NUCLEAR POWER
SYSTEMS DIVISION

MFN 058-81

SUBJECT: ADDITIONAL COMMENTS ON DRAFT OF NUREG-0772

GE COMMENTS ON NUREG-0772 DRAFT

FIGURE B-2
EFFECT OF IODINE CONCENTRATION ON THE
EQUILIBRIUM COEFFICIENT FOR IODINE AT 25°C

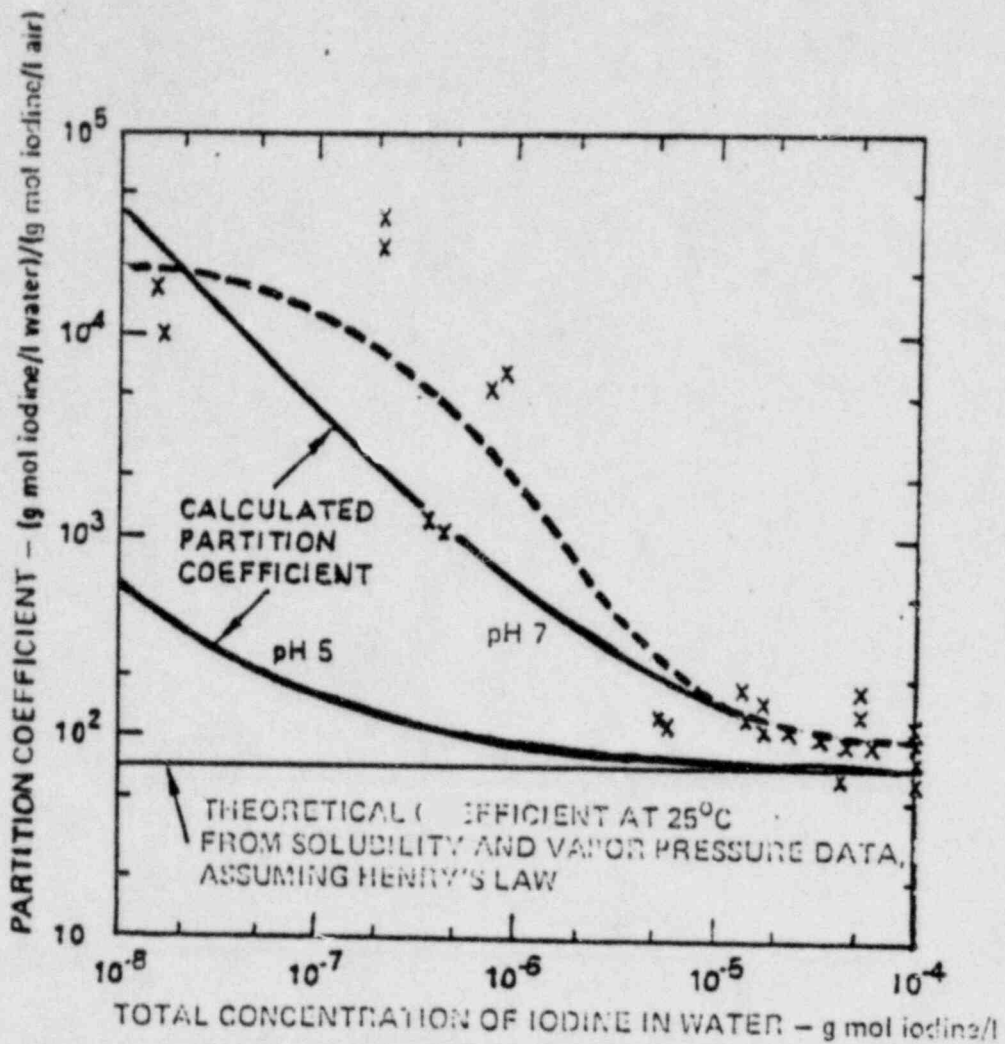
5. Pg. 5.25 - The calculated partition coefficients shown in Figure 5.5 are not consistent with the experimental data reported in the literature (Ref. 2 and 3 see attached figures). At least a factor of 10 - 100 larger should be expected at lower iodine concentrations. It is also important to emphasize that, as given on page 5.26, "the calculated partition coefficients in this paper have assumed an initial iodine source of molecular iodine, I₂, dissolved in water and reacted with water to produce the equilibrium concentrations of iodine species. It should be obvious that solutions where the only iodine species is iodine, I⁻, will have essentially infinite partition coefficients." (See comment B6 for application of partition coefficients in pool scrubbing calculation).
